STAFF RECOMMENDATION

2617 Essex Place

July 20, 2016

Application: New construction—addition and outbuilding; Setback determination

Figures 2 & 3 show the location of the outbuilding and the addition that are to be demolished.

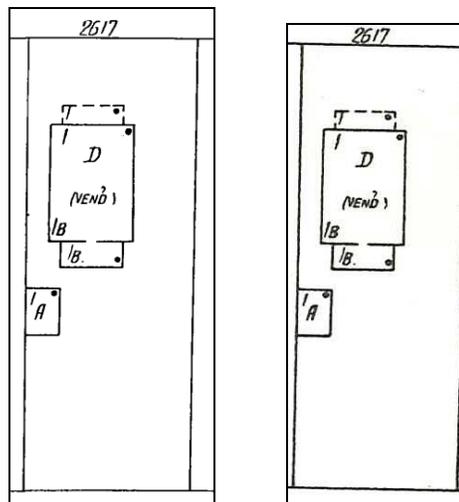
Partial Demolition: The applicant is proposing to demolish an existing one-story, shed roof addition at the rear of the house and an existing outbuilding (Figures 2, 3, 4). The dates of construction of the addition and the outbuilding are unknown, although both elements could be the same addition and outbuilding shown on the 1932 and the 1957 Sanborn Maps (Figures 5 & 6). Despite the fact that the addition and the outbuilding

could date to earlier than 1932, staff does not find them to be contributing elements to the historic house or Hillsboro-West End neighborhood. The addition's shed roof form and materials are different from the rest of the house and its invisibility from the street together mean that the addition is not a defining historic feature of the house. Similarly, the utilitarian design of the outbuilding and its materials does not contribute to the historic character of the house, site, or larger neighborhood. In addition, the outbuilding has likely changed dramatically as it appears to be almost twice the length it was historically. Staff therefore finds that the demolition of the addition and outbuilding meets Section III.B.2 for appropriate demolition and does not meet section III.B.1 for inappropriate demolition.

Figure 8 shows the existing driveway

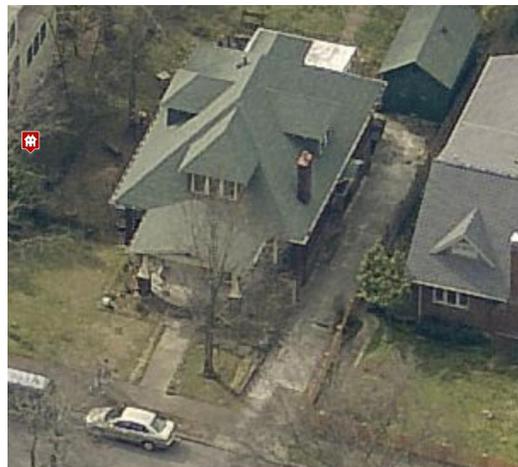
Orientation: The addition will not affect or alter the orientation of the historic house towards Essex Place. The addition of the stairway leading to the side entry on the house will retain the look and feel of a secondary side entry. Vehicular access to the site will not change as part of the application. There is an existing side driveway that will continue to be used (Figure 8). The site also has an alley, which will be used to access the new garage. Staff finds that the proposed addition meets Sections II.B.1.f. and II.B.2. of the design guidelines.
